Your ref: APP/20/00146 – Planning Application for development on site of 17A-17B Avondale Rd.

With regard to the latest planning application for a bungalow on the grounds of 17A-17B Avondale road we have a major objection to the proposal which directly affects us at No. 15 as follows:-

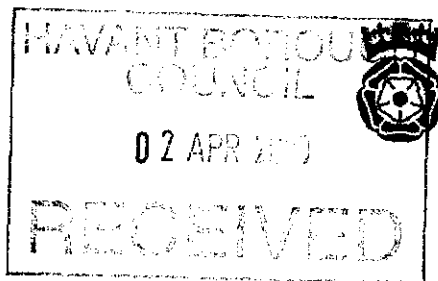
As the slope of Avondale road is downwards from the A3 to Brookline drive the surface water flows down across all gardens to eventually dissipate away in the drains in Brookline drive & beyond into the Hermitage stream at the bottom of Avondale road. However, following this winters rain we have again endured significant surface water backup in our garden as shown on the attached copy of the bungalow plans. This surface water can take many days to dissipate depending on the duration & volume of rainfall.

If the proposed plans went through, the depth of the bungalow footings would effectively act as a Dam Wall for the full length of the bungalow (approx 38ft) on the other side of our fence. This would make our flood problem much worse not only in respect to further damage to our shrubs and vegetation but also to our safety as our garden path would become fully submerged. This is not acceptable. **Please note** that flooding problems in this area have already been noted by Winchester Council in the attached letter to us in Feb. 2020.

Suspected alignment of ordinary watercourse to Hermitage Stream

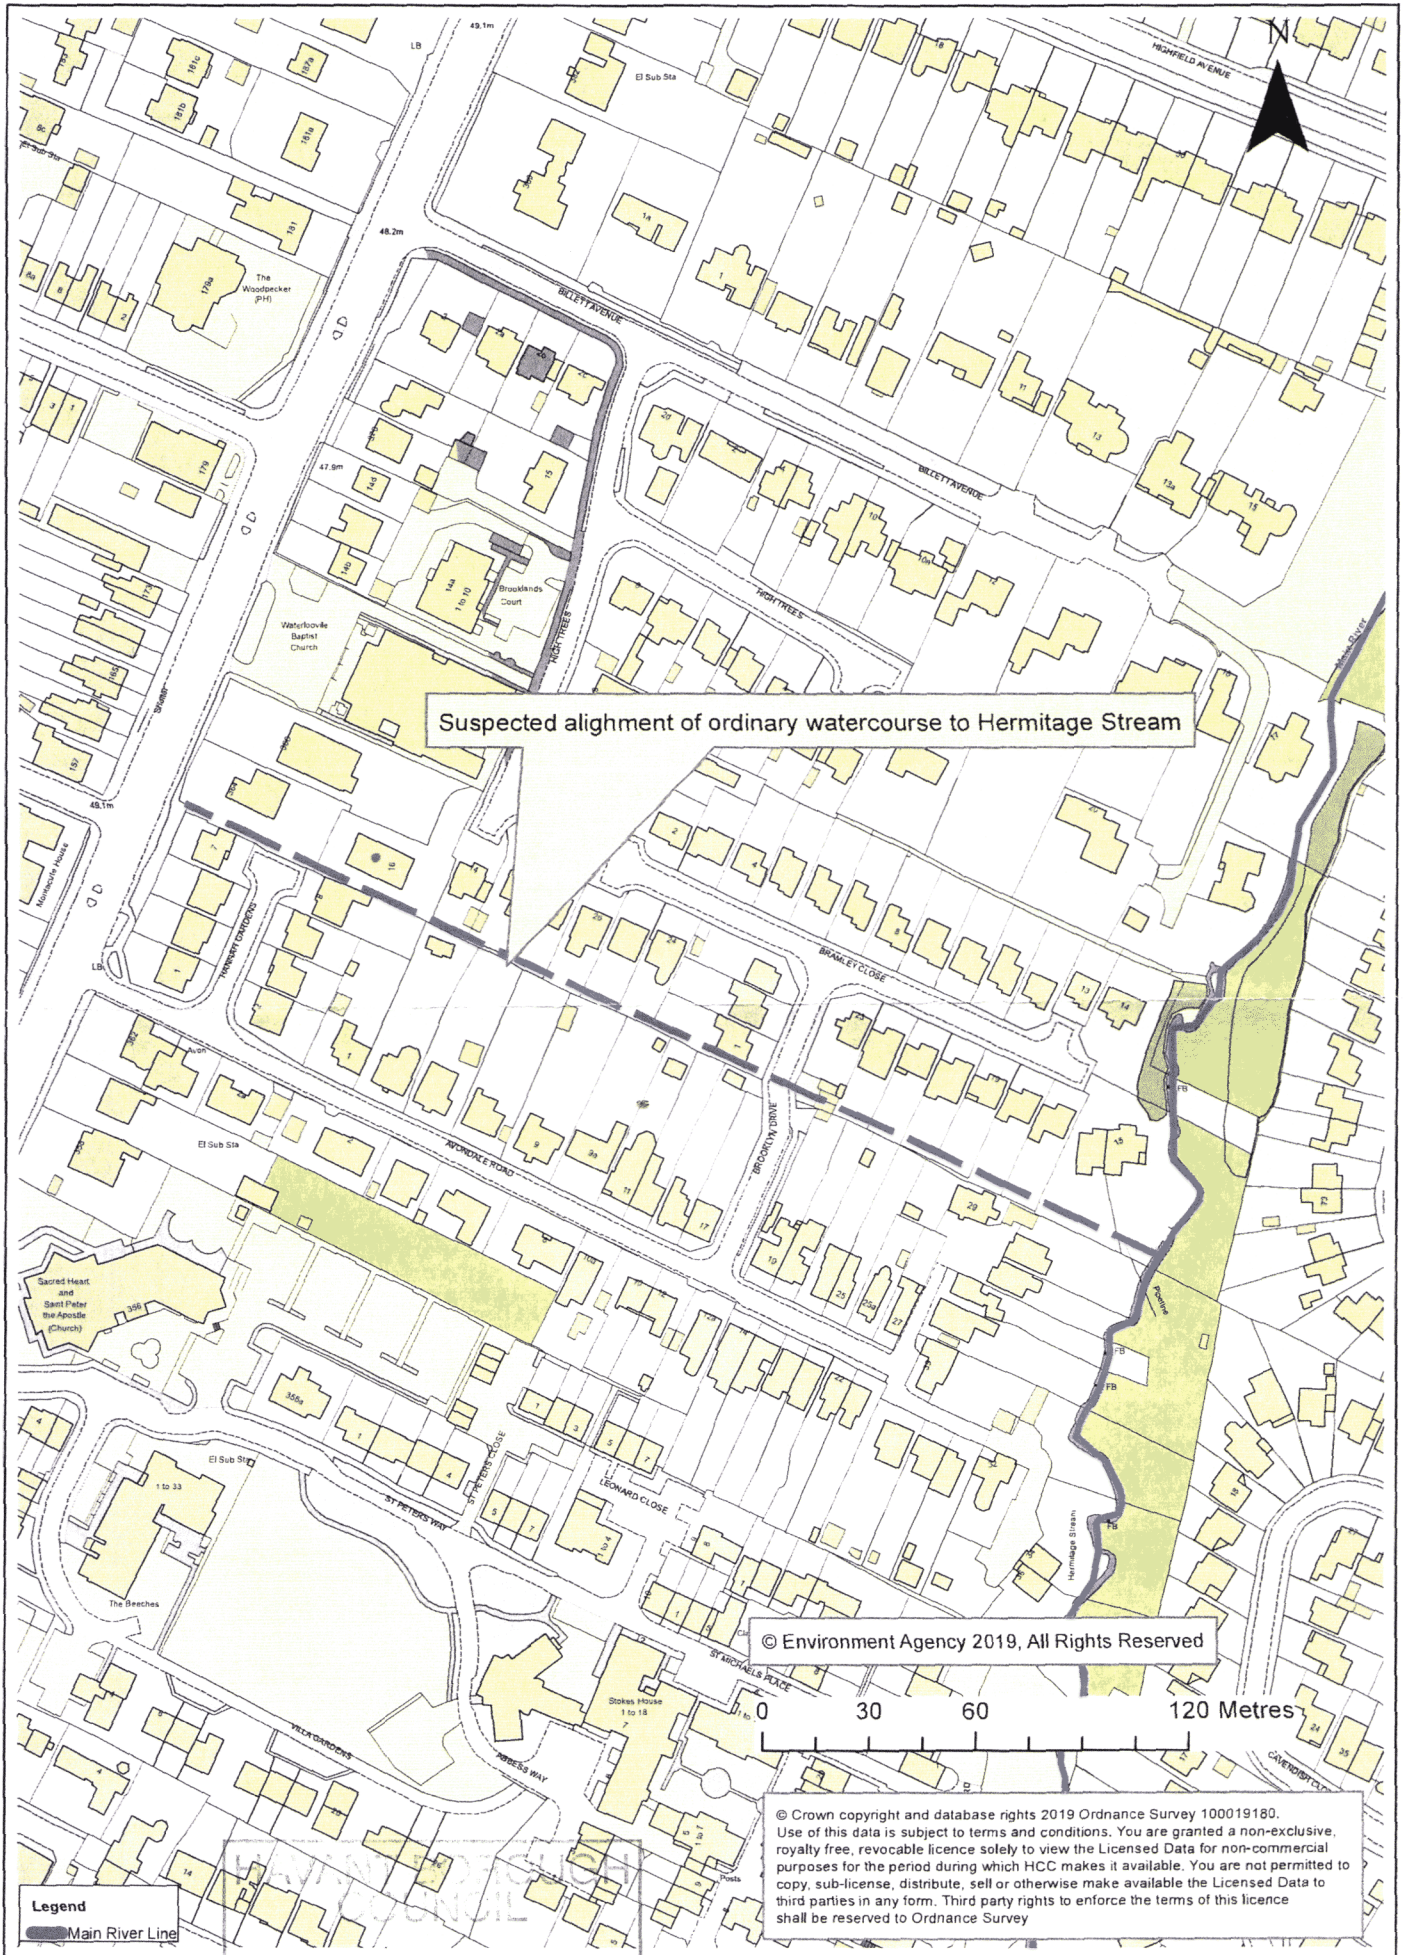
During a site visit to the property '16 High Trees' to investigate flooding that had recently affected the property, a Hampshire County Council Flood Investigations Officer noted that there was a blocked surface water drainage culvert which is used to convey this watercourse. This was subsequently cleared by a drainage contractor to the boundary with No. 14 High Trees/3 Avondale Road however it was noted that water was still not draining from this pipe which indicates there is a further blockage downstream of this point.

The watercourse in question is believed to continue in an approximate straight line along between the rear gardens of 11/12 High Trees, 24/25/26 Bramley Close and 3-17

Avondale Road in a south easterly direction to the Heritage Stream, highlighted as a **blue dashed line** on the attached map.

proposed ground floor plan
scale 1:200 @ A3 1:100 @ A1

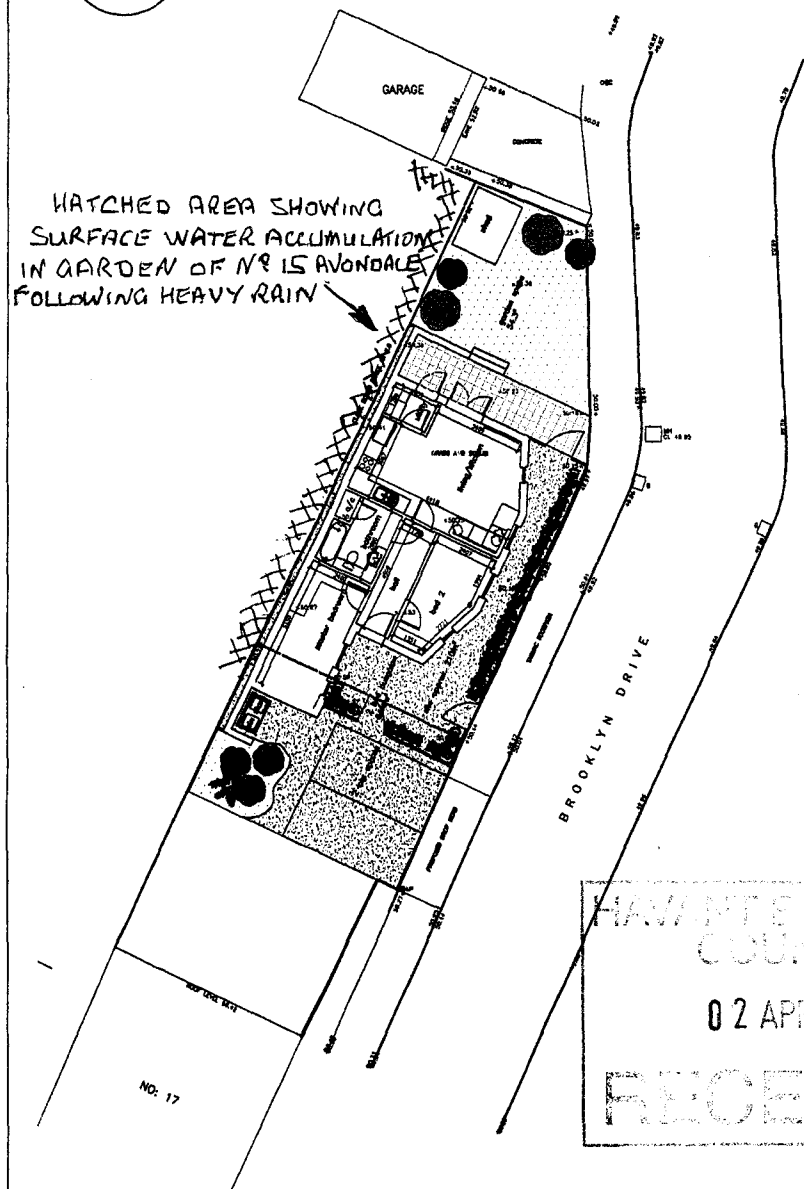
- 1) Firstly, the two proposed parking slots for the bungalow will be negated by the loss of two 'on road' parking places.
- 2) The parking congestion in Brooklyn Drive & the juncture with Avondale road is still the cause of acrimonious exchanges as vehicles vie for any remaining spaces.
